UNITED STATES PATENT AND TRADEMARK OFFICE

10/603,947

The Examiner's Answer mailed on 06/09/2009 inadvertently excluded claim 150 from the section titled "(9) Grounds of Rejection".

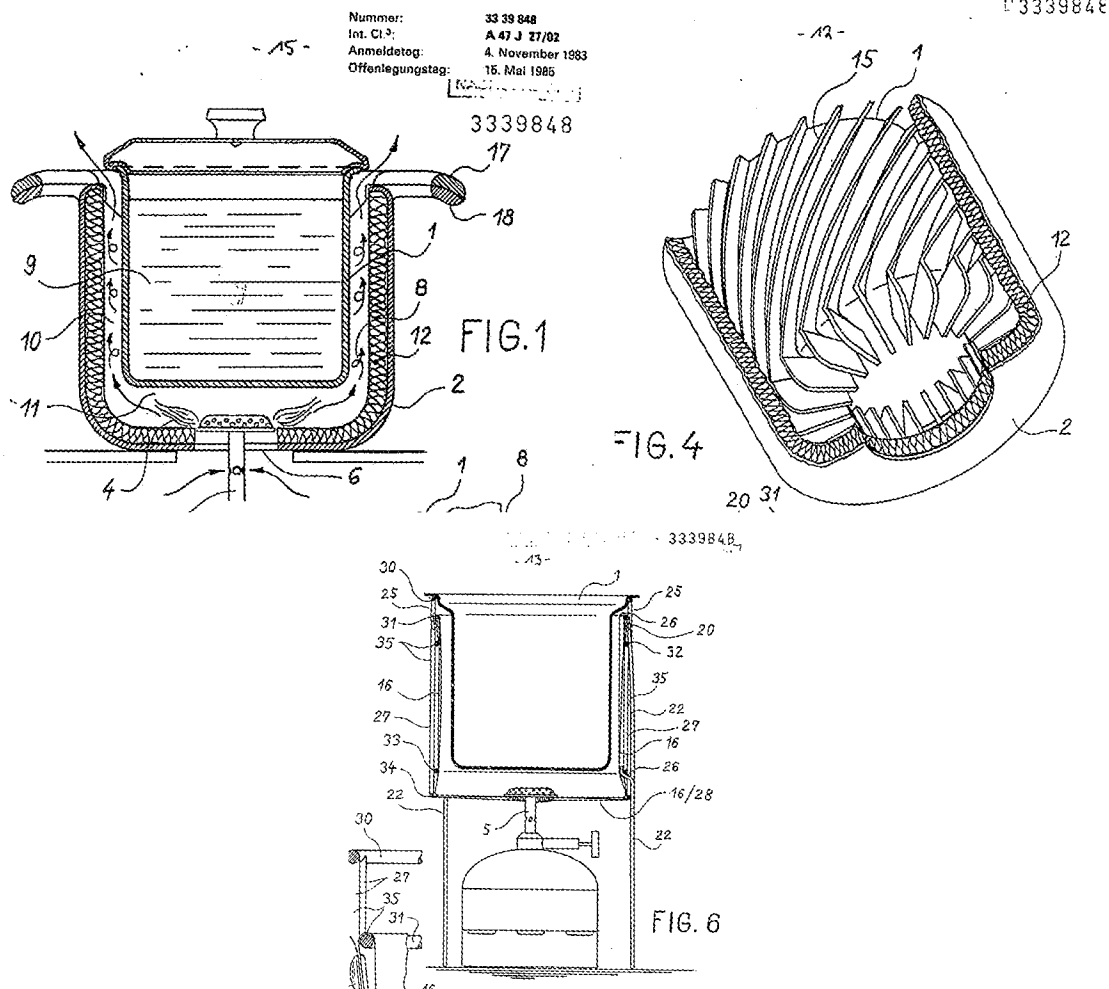
- a vessel (13) having a thermally conductive bottom end defining an external bottom side (31, 32, 33) of the vessel;
- a top housing (16) having a top rim (53) coupled circumferentially to the external bottom side of the vessel (at 32, 53), a side structure (54) extending downwardly from the top rim (53) and having a plurality of exhaust vents (82) formed therein, and a bottom rim (48, 51);
- a bottom housing (17) having a top rim (49, 52) configured to be selectively coupled to the top housing bottom rim (48) and containing a burner (15) having a heat outlet head disposed below the external bottom side of the vessel when the bottom housing is coupled to the top housing (see figure 8), the bottom housing further having a plurality of air inlet vents (81) formed therein.

US002154305 shows and discloses the invention substantially as set forth in the claims with possible exception to:

- a single thermally conductive member (15) along the entire extent of a peripheral edge of the external bottom side. The member comprising a continuous piece of aluminum material soldered to and positioned adjacent to and extending continuously over the bottom of a vessel (see page 2, lines 100-105).
